ENGINEERING INSTRUCTION

**SUBJECT: ALTERNATE BOX BEAM GUIDE RAIL
TERMINALS IN BACKSLOPE AREAS**

Code: EI 81-32

Date: 7/28/81

ALTERNATE BOX BEAM GUIDE RAIL TERMINAL
WHEN RAIL TERMINATES IN BACKSLOPE IN SOIL

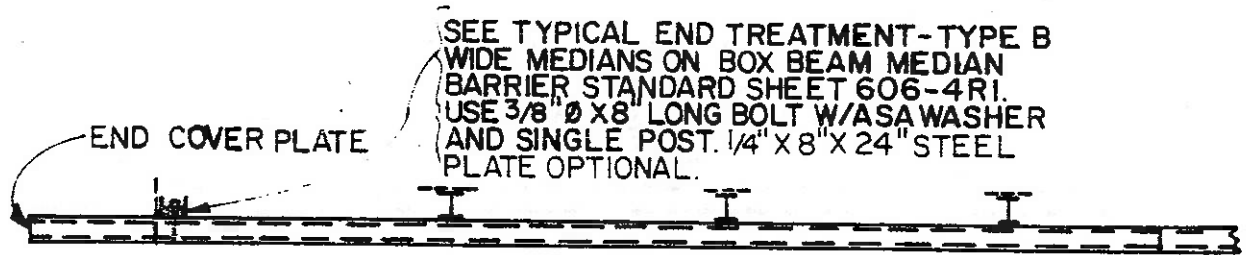
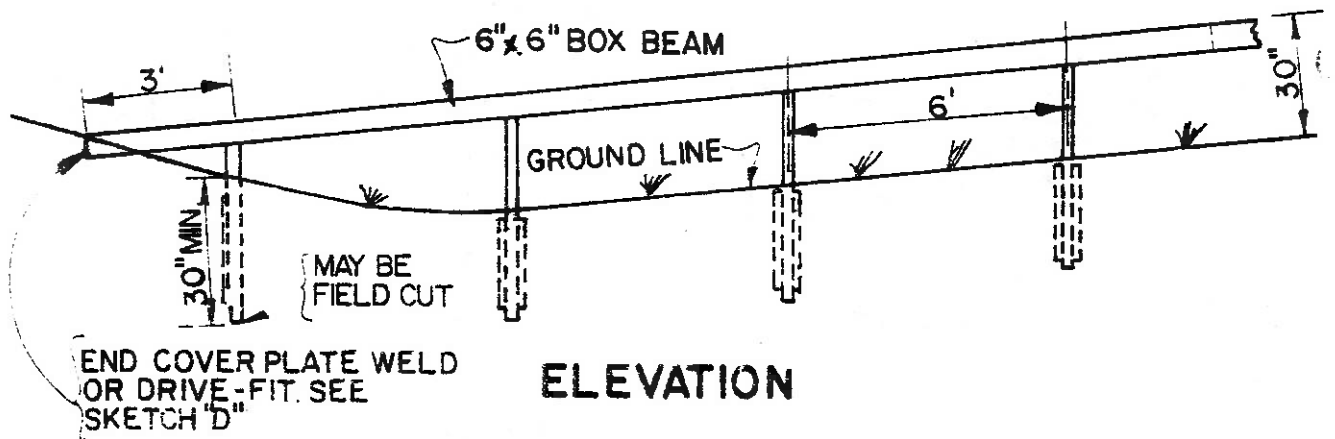
ADD THE FOLLOWING DETAIL TO STANDARD SHEET 606-3R2.

1. SHOP CURVED OR STRAIGHT AS DIRECTED BY ENGINEER.
PAYMENT UNDER APPROPRIATE ITEM.
